### 3.5 Missile Protection

STP DEP 3.5-1 (Table 3.5-1 and Figure 3.5-2)

Figure 3.5-2 Low-Trajectory Turbine Missile Ejection Zone

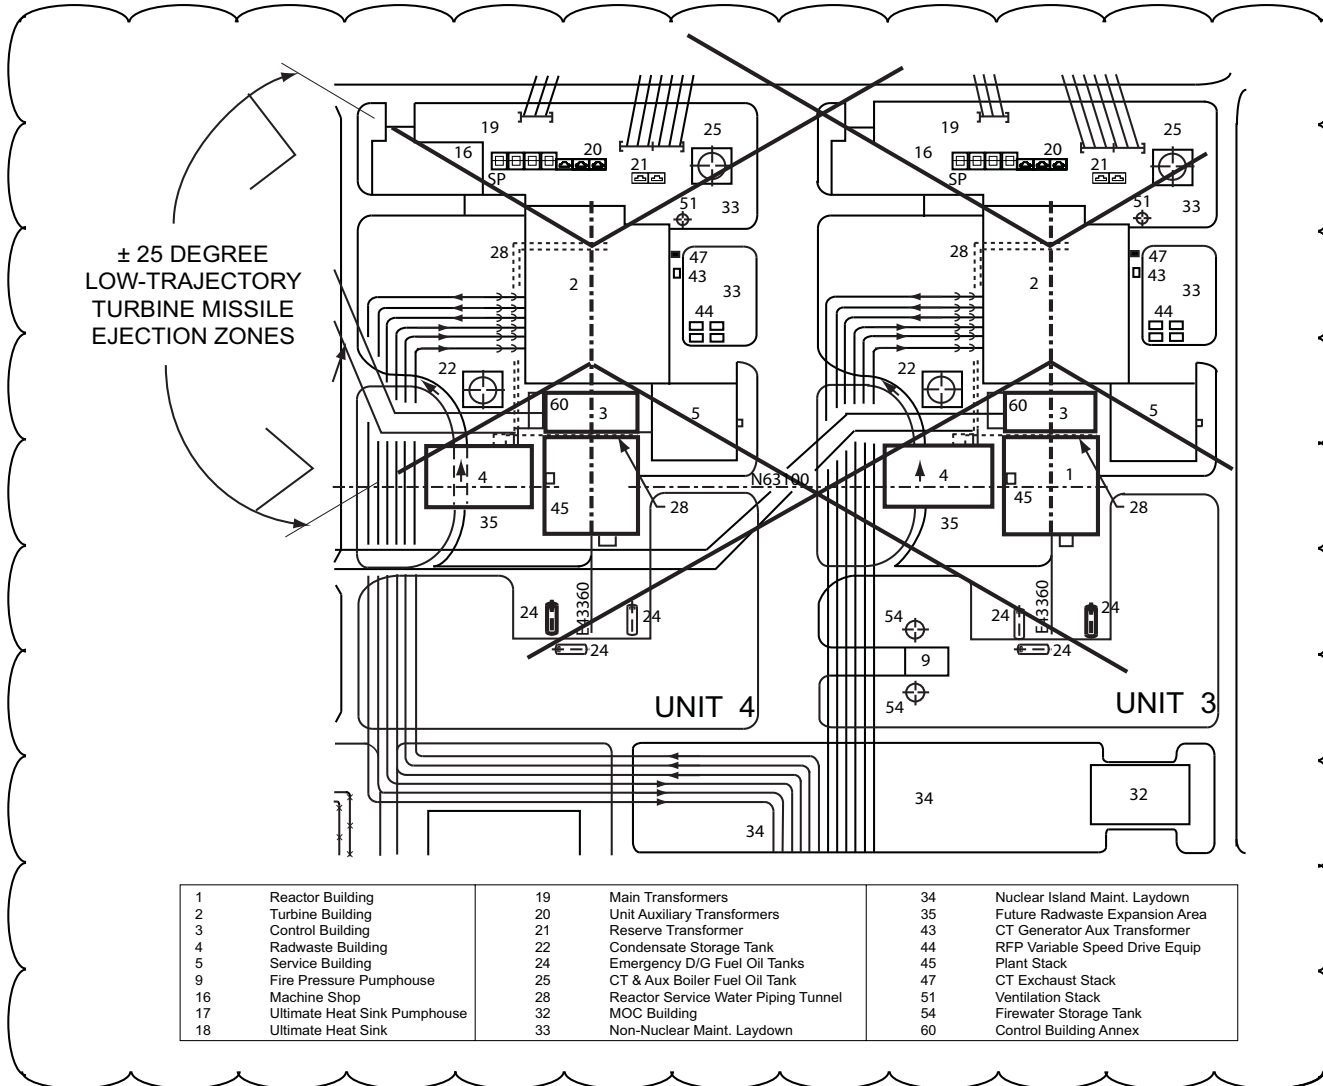
~~Acceptance Criteria 1 of SRP Section 3.5.1.3 considers a plant with a favorable turbine generator placement and orientation and adhering to the guidelines of Regulatory Guide 1.115 adequately protected against turbine missile hazards. Further, this criterion specifies that exclusions of safety-related structures, systems or components from low trajectory turbine missile strike zones constitutes adequate protection against low trajectory turbine missiles. The turbine generator placement and orientation of the ABWR Standard Plant meets the guidelines of Regulatory Guide 1.115 as illustrated in Figure 3.5-2.~~

The STP 3 & 4 turbine generator placement and orientation in relation to essential systems of the adjoining unit are illustrated on Figure 3.5-2. Per Regulatory Guide 1.115, the STP 3 & 4 turbine generator placement and orientation is considered unfavorable. Per Acceptance Criteria 1 of Standard Review Plan Section 3.5.1.3 for unfavorable turbine generators, a value of  $10^{-2}$  per year per plant was chosen as a conservative value for the product of strike probability ( $P_2$ ) and damage probability ( $P_3$ ). The criteria for unfavorable turbine generator orientation given in Standard Review Plan Table 3.5.1.3-1 and provided in Table 3.5-1 was assumed for the missile generation probability ( $P_1$ ). The resulting probability of unacceptable damage from a main steam turbine missile ( $P_4$ ), which is  $P_1 \times P_2 \times P_3$ , is less than  $10^{-7}$  per year per plant.

Therefore STP 3 & 4 main steam turbine generator placement and orientation meets the acceptance criteria of Standard Review Plan 3.5.1.3 and the guidelines of Regulatory Guide 1.115.
